**Project Name: \*** Widening of I-95 to Eight lanes from South of SR 1832 (Murphy Road – Exit 56) to South of SR 1811 (Bud Hawkins Road – Exit 70)

## I-5986A 4C Interagency Concurrence Point Meeting Minutes

Subject: Modification Request for Section 404 Individual Permit, Section 401 Water Quality Certification and Neuse Riparian Buffer Authorization for the Widening of I-95 to Eight lanes from South of SR 1832 (Murphy Road – Exit 56) to South of SR 1811 (Bud Hawkins Road – Exit 70), in Cumberland County, STIP No. I-5986A. Debit \$575 from WBS 47532.3.2.

# PERMIT DRAWING SHEET 79 OF 163

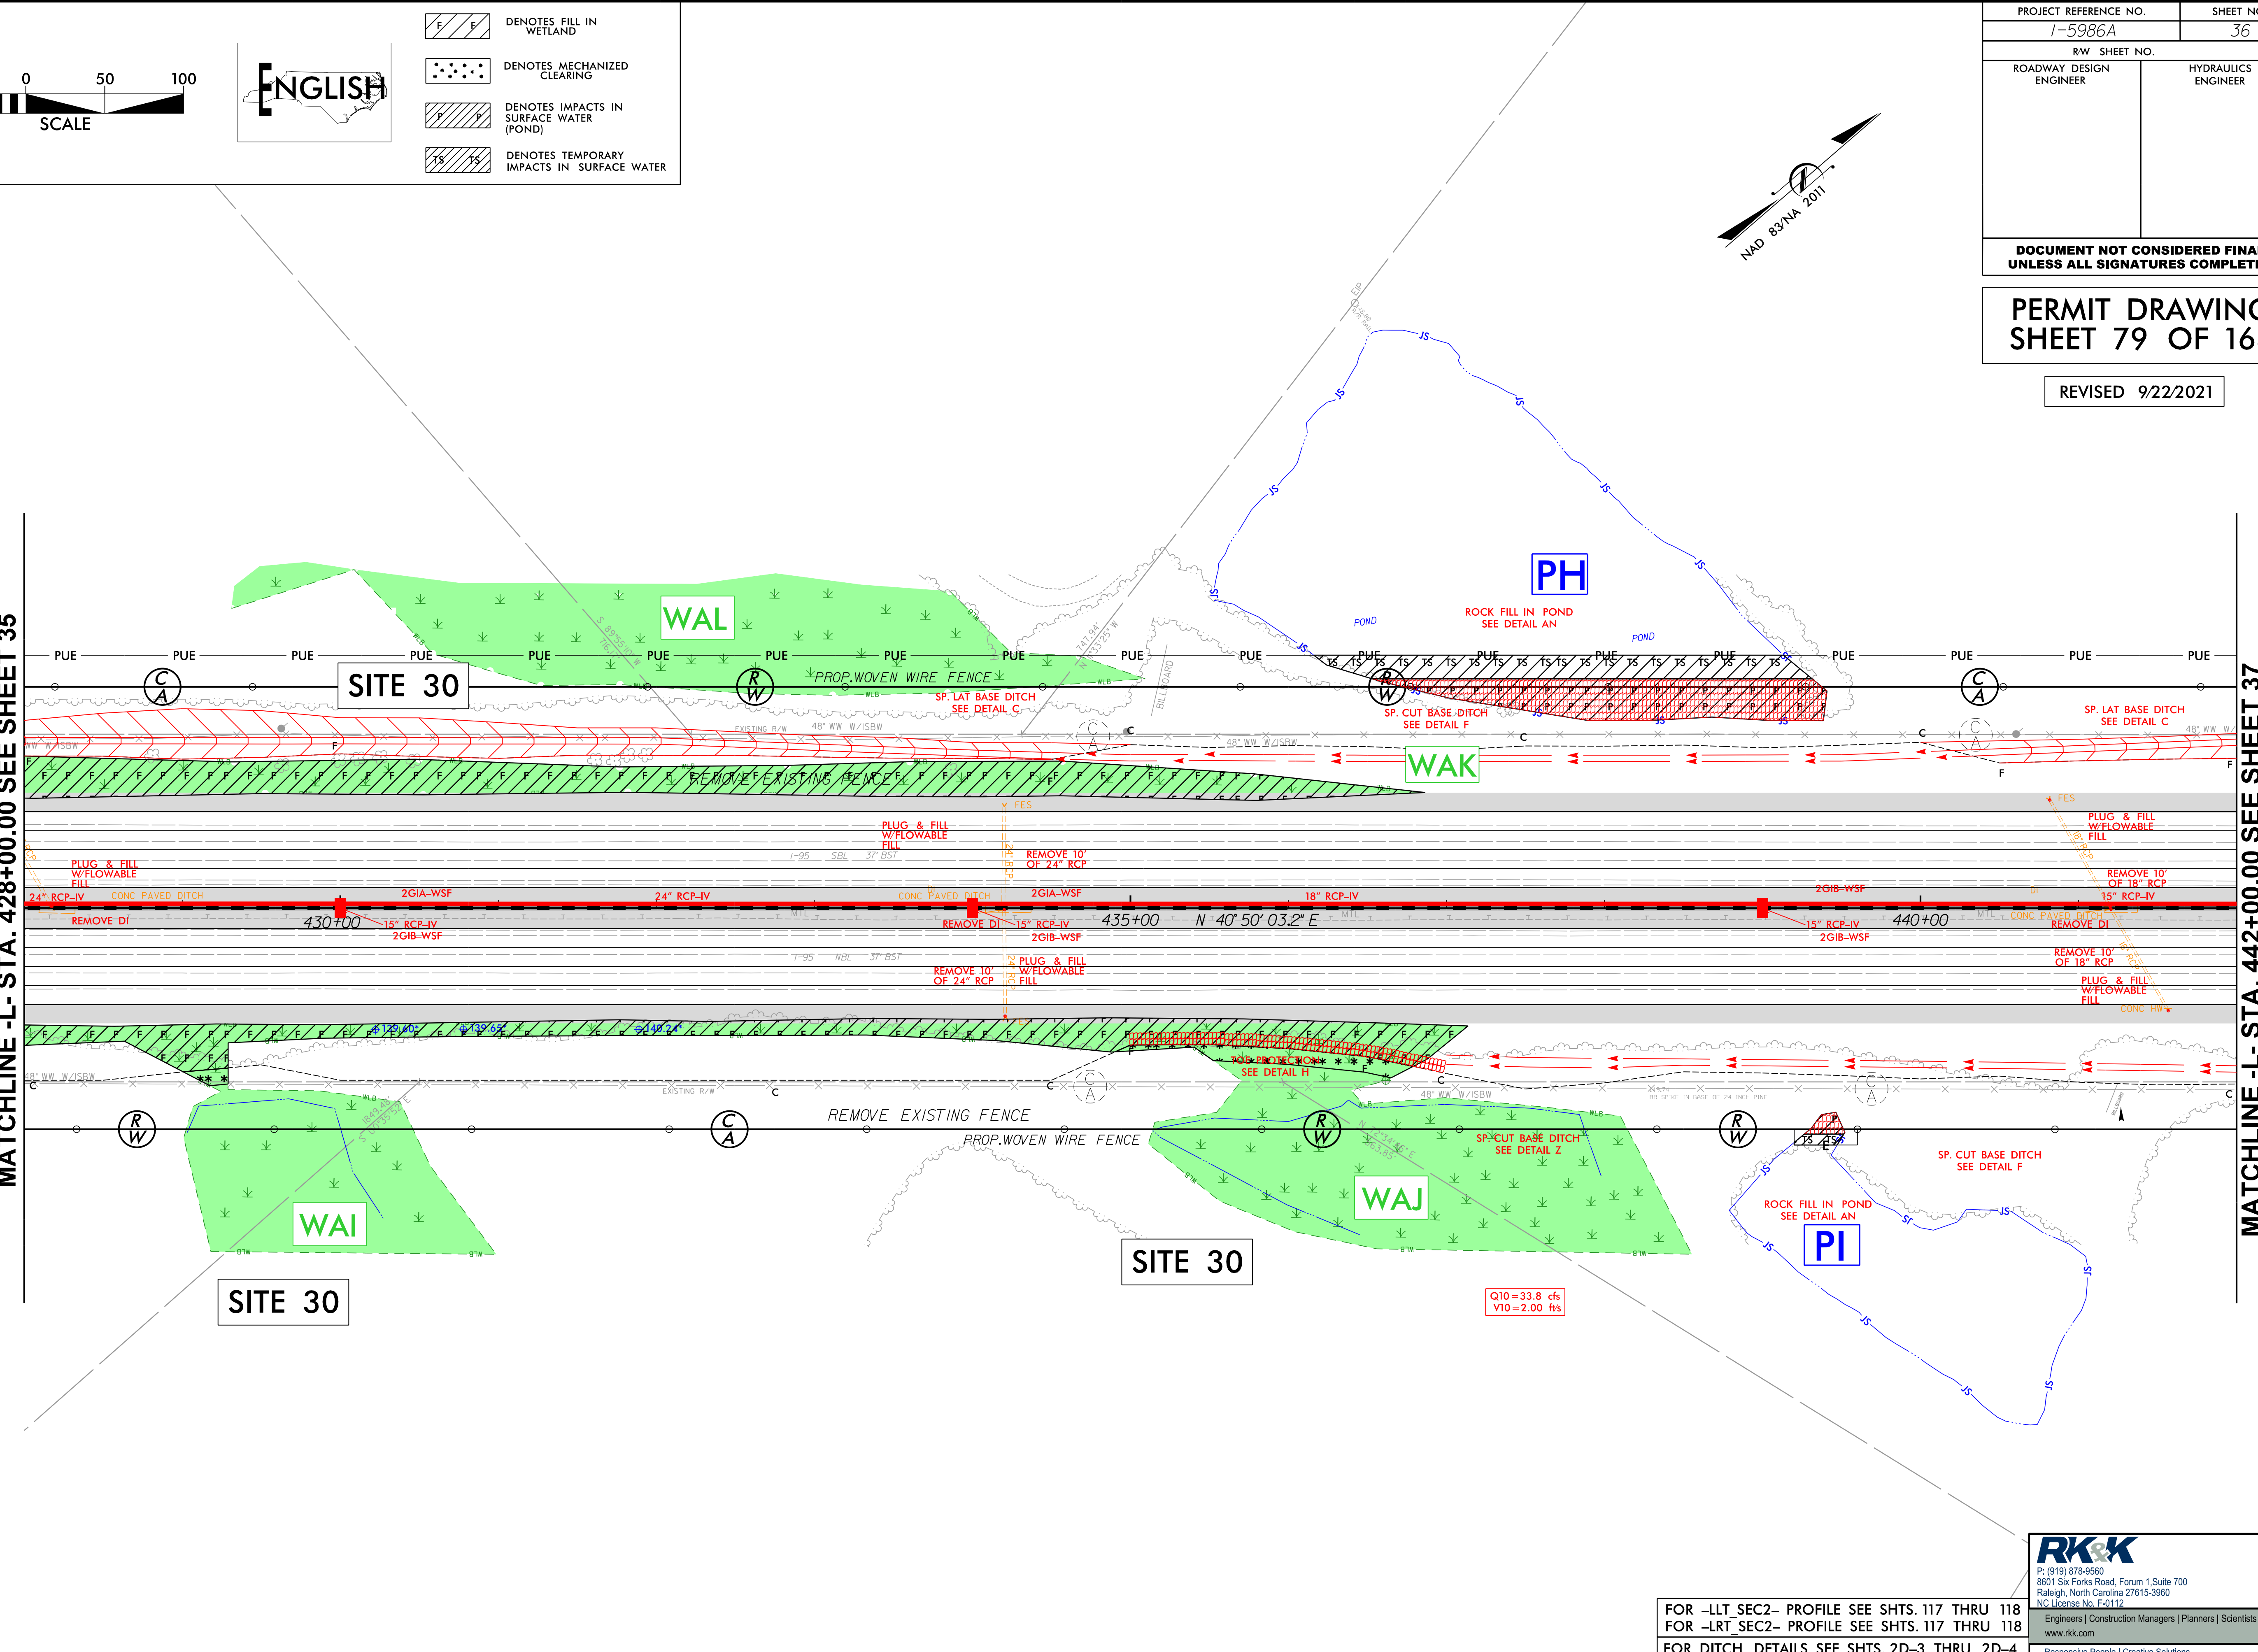
The right-of-way (ROW) was adjusted from the time of the original application that has resulted in surface water impacts to two ponds, PH and PI. There were no previous impacts to these ponds, so they have been incorporated into Site 30 and summarized below.

**Site 30.** These impacts are due to ROW adjustment
